David Fowler  
Principal Planner  
Regeneration and Planning  
Culture and Environment  
London Borough of Camden  
5 Pancras Square  
London  
N1C 4AG

**Planning Application: 2017/6306/P**

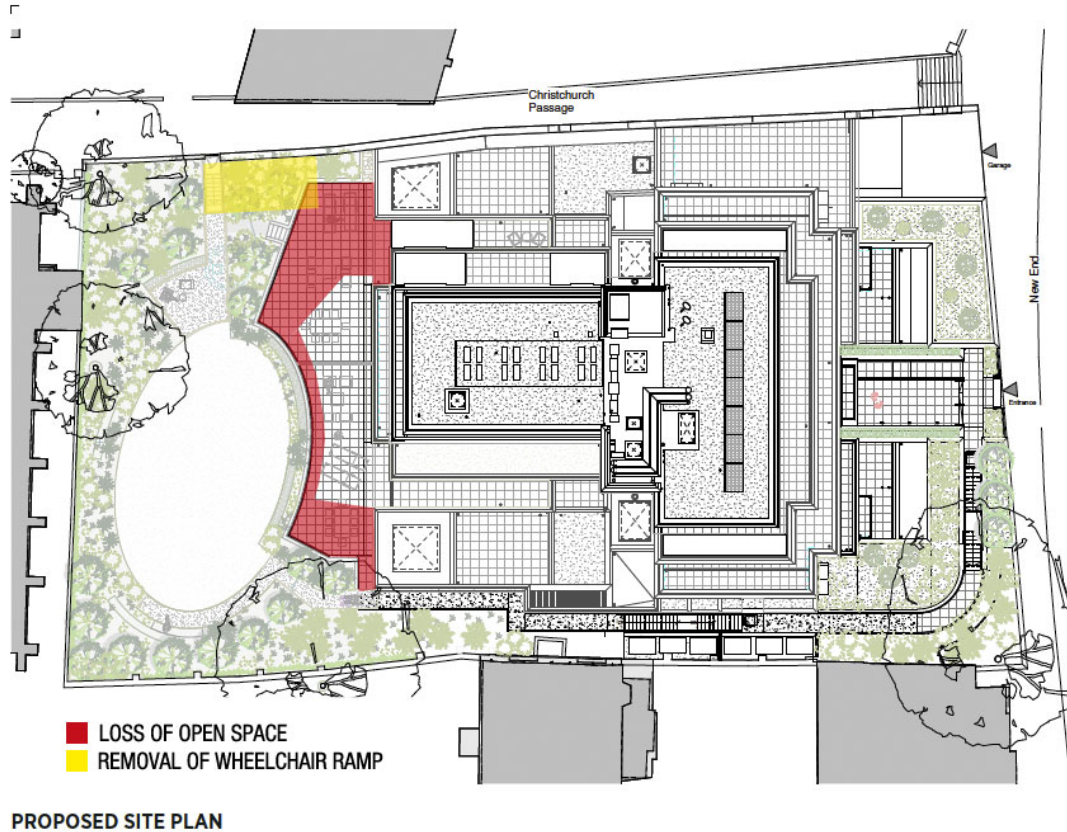
As well as the additional roof plant for air conditioning condensers, a further installation is proposed to run the entire length of the garden of the adjoining Grade II listed Lawn House.

No revised noise report has been submitted with the application to demonstrate that the newly proposed plant locations satisfy the Planning Inspectorate's Condition 13 that states:

It would seem therefore that, until such time as a suitable noise report or assessment has been submitted covering all of the surrounding buildings, the Council should not approve permission for the proposed air conditioning plant locations.
